CITY OF PORTLAND, MAINE
Application for Permit to Install Wires

SUBJECT: Building Code appeal concerning change of use to church purposes of building at corner of Island Avenue and Central Avenue, Peak Island

Conversion of former telephone building at Peaks Island to public school

Change of Use - Island Ave., corner of Central Ave. (P7-FT-4)

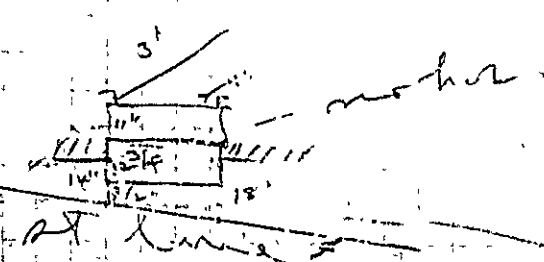
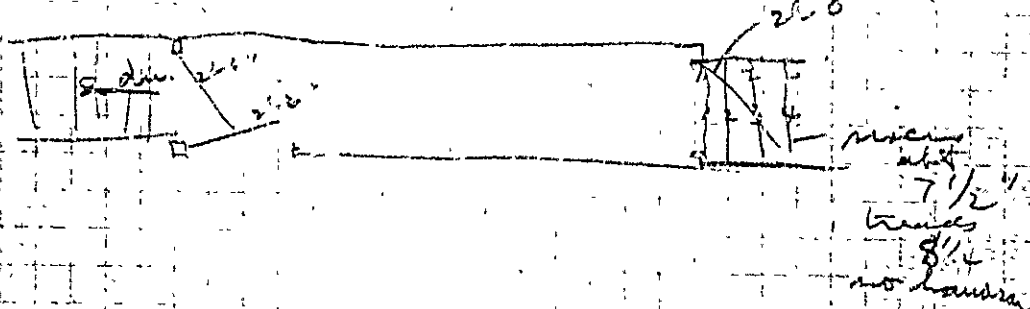
- All parts of the building is more than 20' from the nearest property line.
- The cellar stairs, if any, are enclosed with fire resistive partitions and a self-closing fire door at the foot.
- The ceiling of the cellar is plastered on metal lath.
- The heater, fuel storage and smoke pipe are enclosed in a masonry walled heater room with fire door.
- Exit doors are sufficiently separated, swing out without a step down under the outward swing of the doors, are of the required width, are equipped with anti-panic hardware.
- Whether toilet room has a water proof and sanitary floor surface and base.
- Whether floor level is more or less than 4' above the grade.

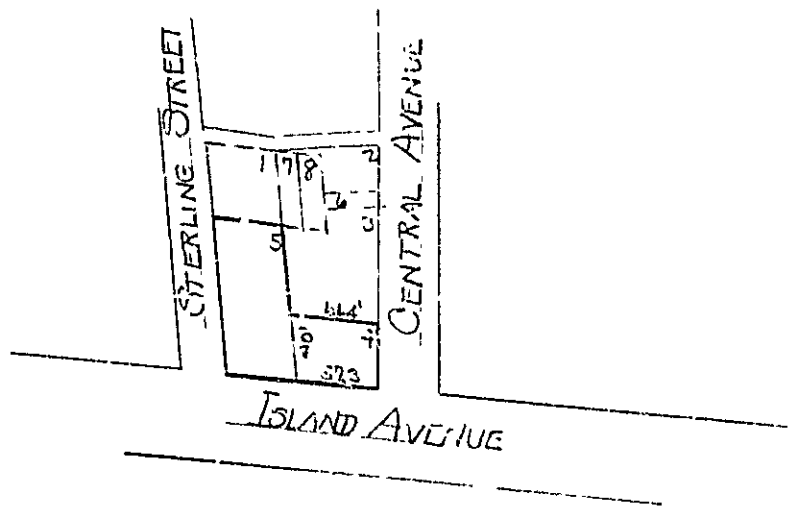
Check of application for permit for change of use of building at above named location to church use discloses (aside from question as to closeness to rear lot line which is the subject of another letter) the following questions as to compliance with Building Code requirements:

1. An additional column beneath pier is needed for the 9 foot span at rear of building. If feasible, it would be desirable to space the new and the existing columns equally between the rear wall and the splice in girder at about the center of the building.

2. Our records indicate that the second column in from Island Avenue is an iron pipe badly rusted where it enters concrete floor. If this condition still exists, it should be replaced and column relocated so as to be halfway between center splice and rear 6x6 post to be introduced near front of building.

3. It is understood that rear door on side of building farther from Island Avenue is equipped with anti-panic hardware. Such locking hardware is O.K. and this door will serve as the required second means of egress from the building. When platform outside this door is reframed, care should be taken to have surface of platform no lower than the thickness of the usual threshold below floor of building so as to avoid any appreciable stepdown. An exit sign is required over this door.

4. Unless already so equipped, front entrance door is required to have a vestibule double set, which is one which may always be opened from inside without the use of a key, even though the door is locked from the outside.

Information needs to be furnished as to how these details will be cared for.

full 6x8

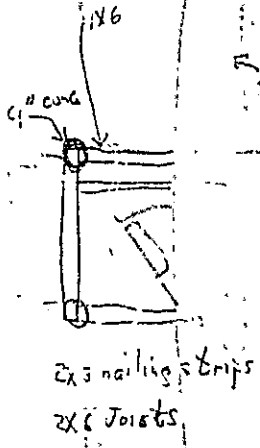
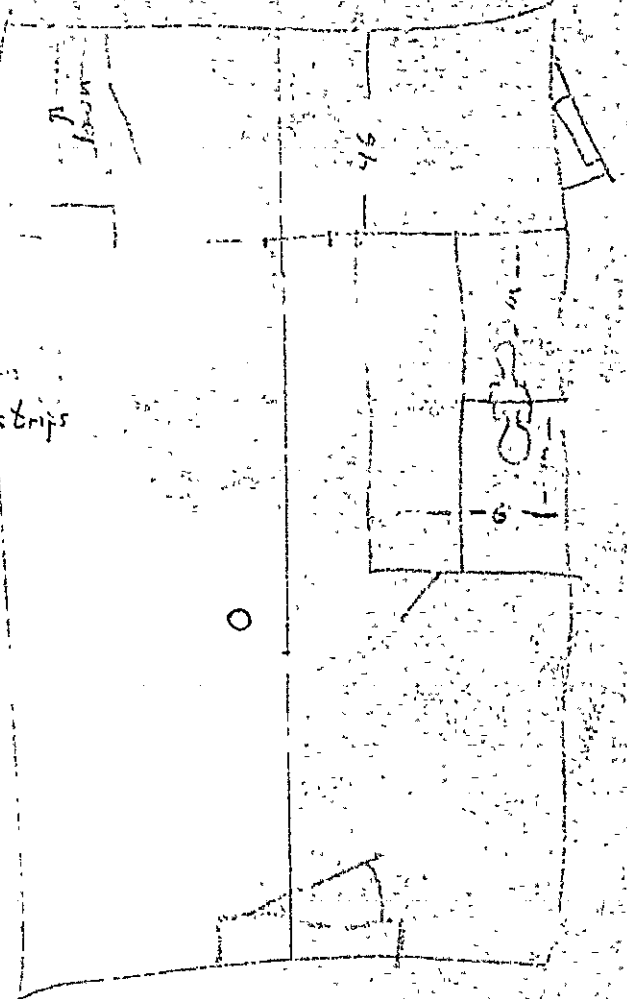
4 cement form
with 3 courses
of 2x8 concrete
blocks

2x6 Joists
2x6 nailings strips
